**CITY OF ISLE OF PALMS, SOUTH CAROLINA
REQUEST FOR BIDS (RFB) 2025.04
WILD DUNES GOLF COURSE- FLOOD MITIGATION IMPROVEMENTS
Response to Questions August 19, 2025**

FLOTATION NOTES:
THE PIPE IS ASSUMED TO BE EMPTY WITH GROUNDWATER TO THE GRADE SURFACE AND SATURATED SOIL DENSITY OF 130 PCF. IF THE PIPE IS FULL OF WATER THESE VALUES MAY BE ADJUSTED BY THE SITE DESIGN ENGINEER. FOR MORE INFORMATION ON FLOTATION, REFER TO ADS TECH NOTE TN 5.05.

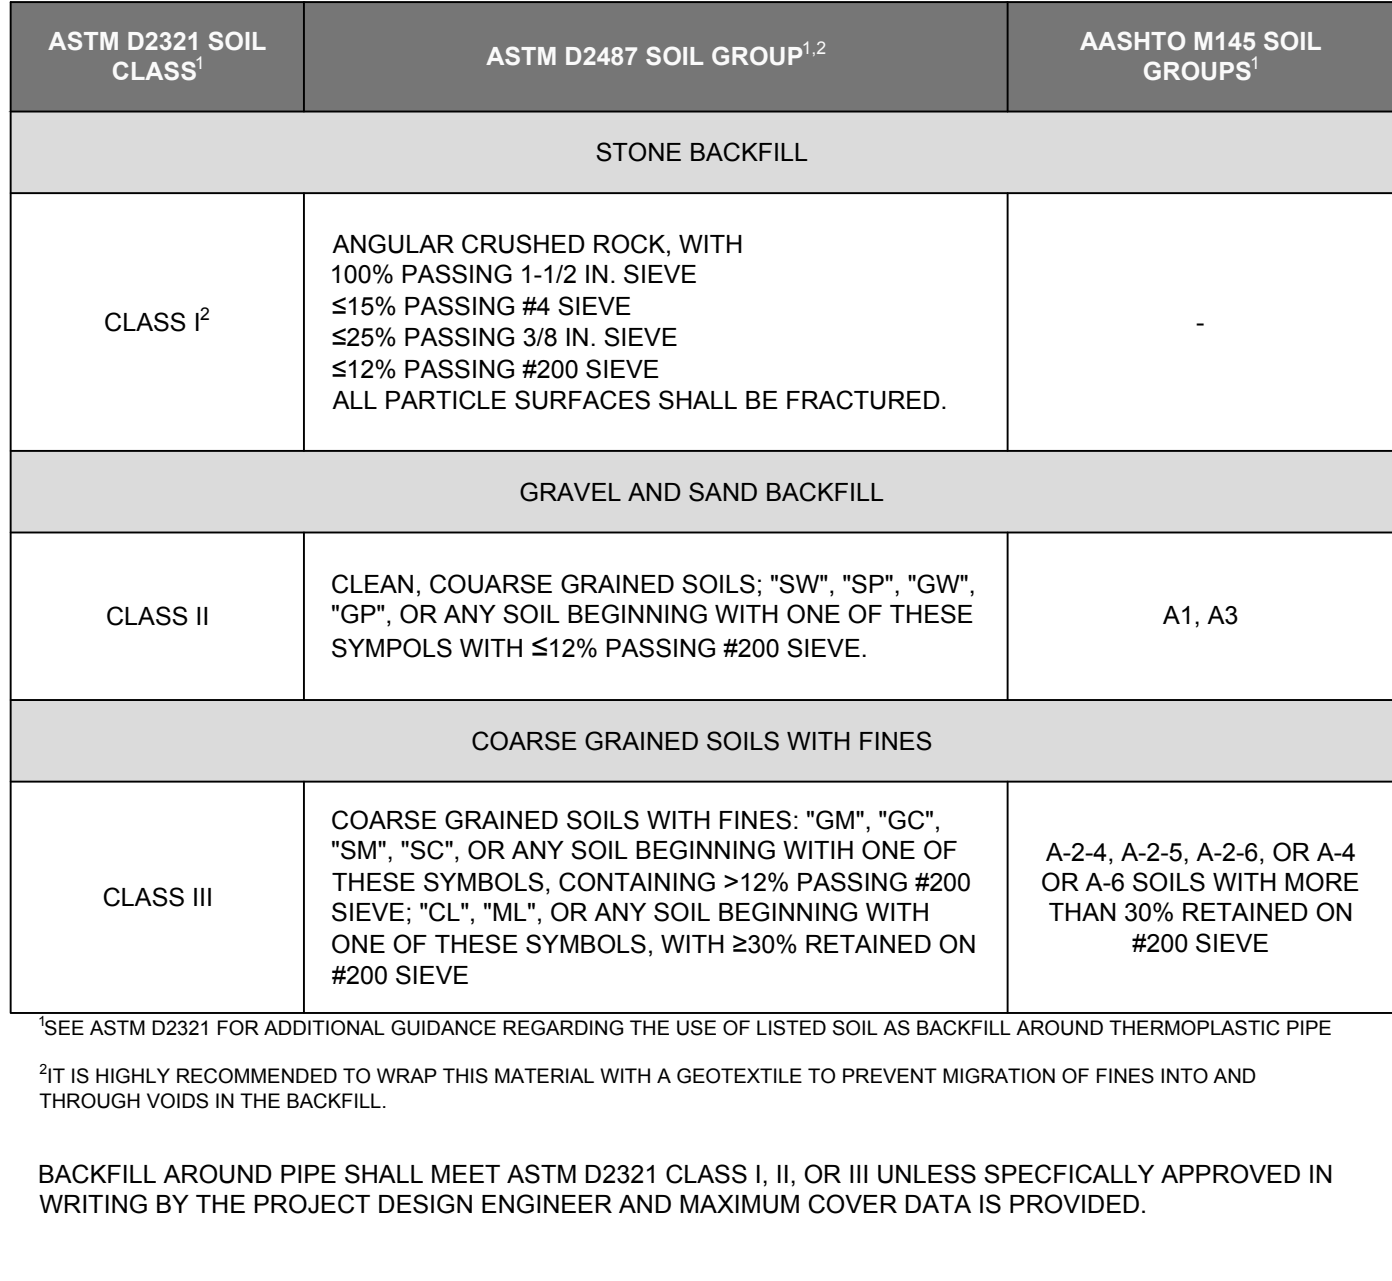
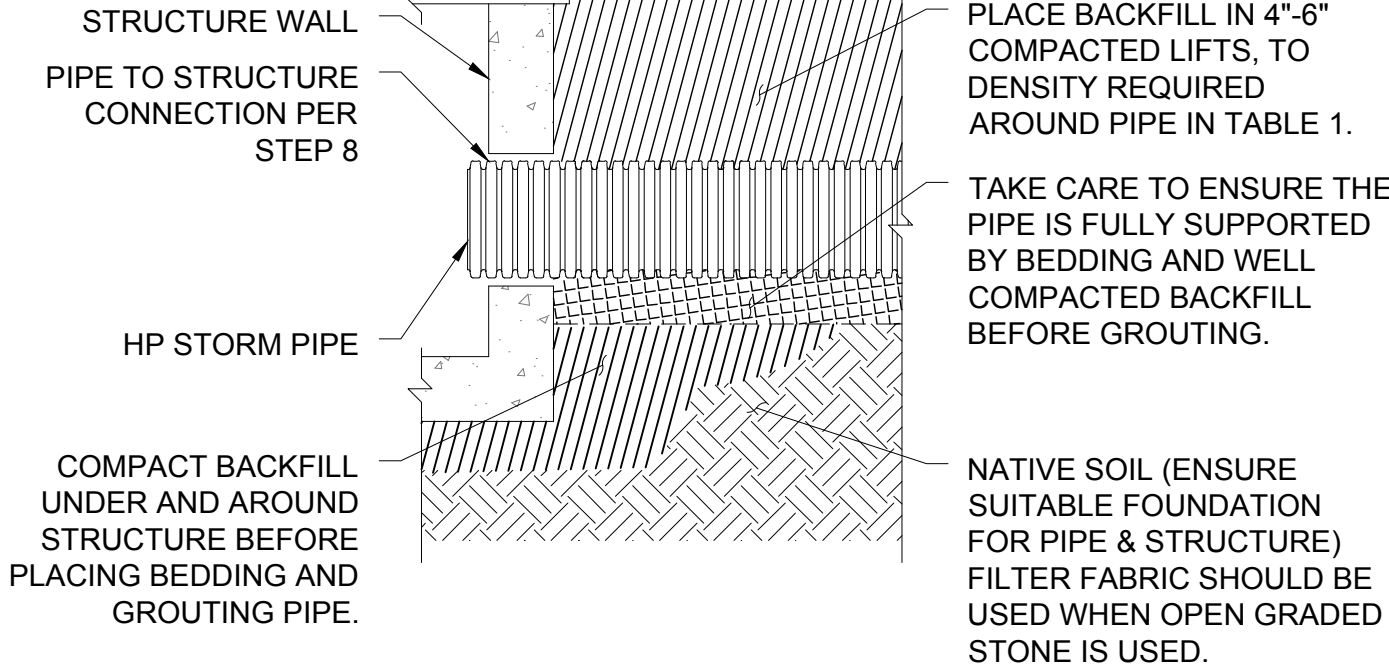
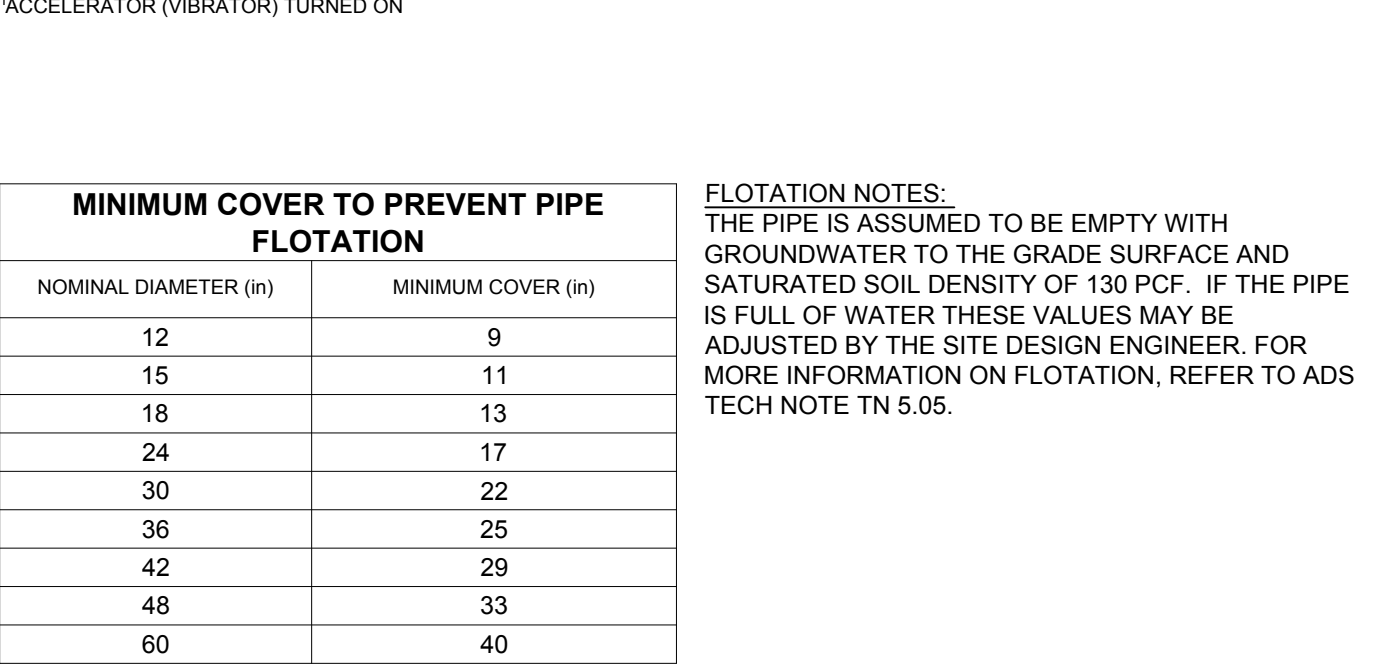
16. Should any bedding material be anticipated for HDPE pipe?

Response: all HDPE pipe shall be installed per the manufacturer's recommendations. Attached are the recommendations for ADS branded pipe. If the contractor uses ADS – they should follow these recommendations. The contractor can propose alternate brands, but should provide installation recommendations and the alternate must be verified for meeting the needs of the project prior to installation.

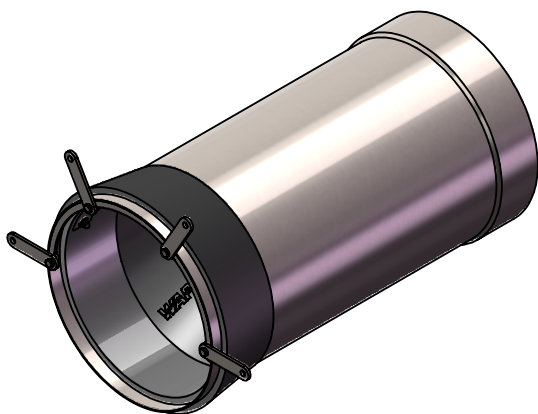
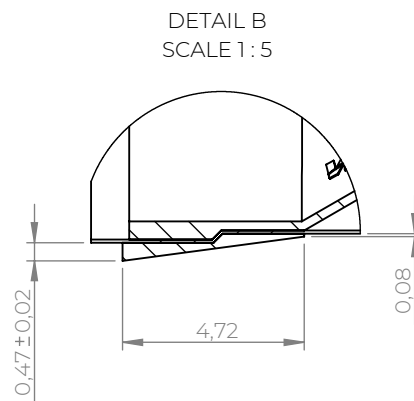
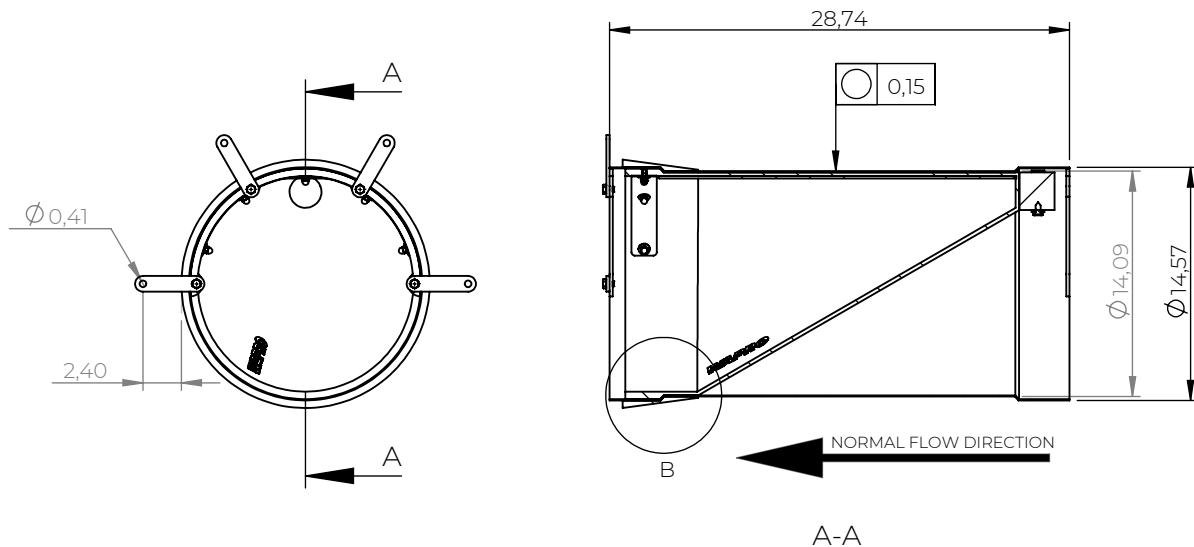
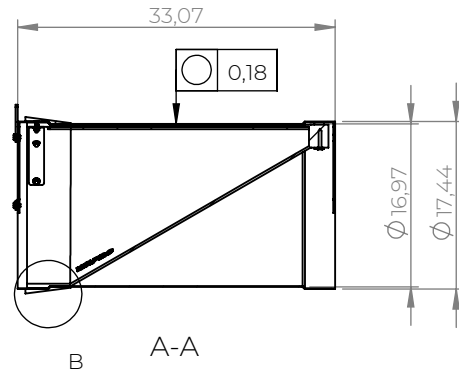
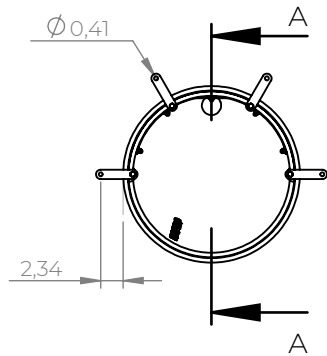
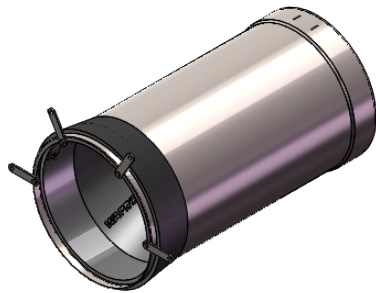
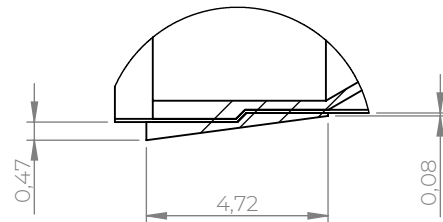
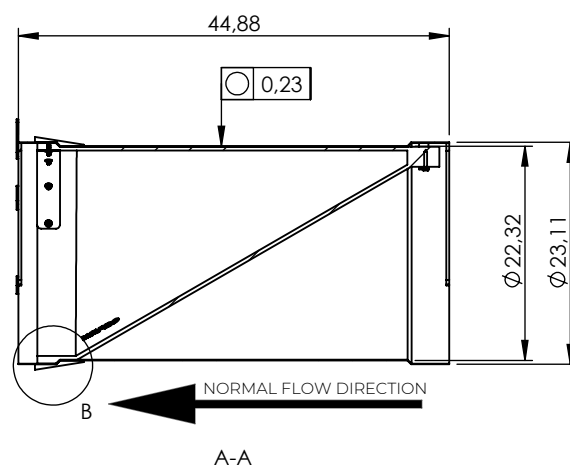
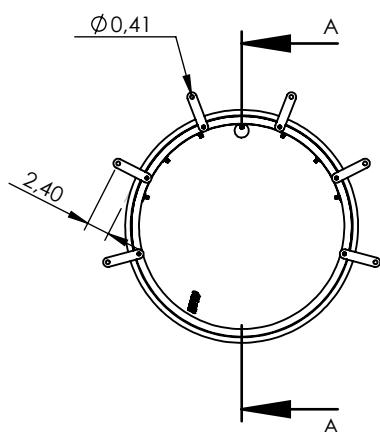
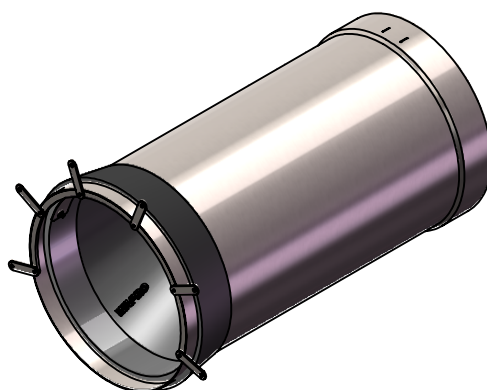
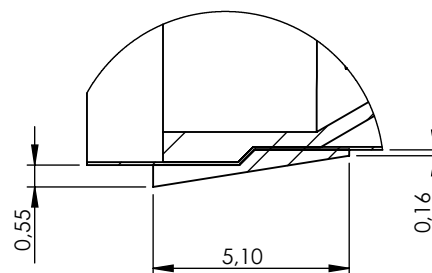
14. Do we have installation details on the in line Wapro check valves?

Response: see attached installation specifications
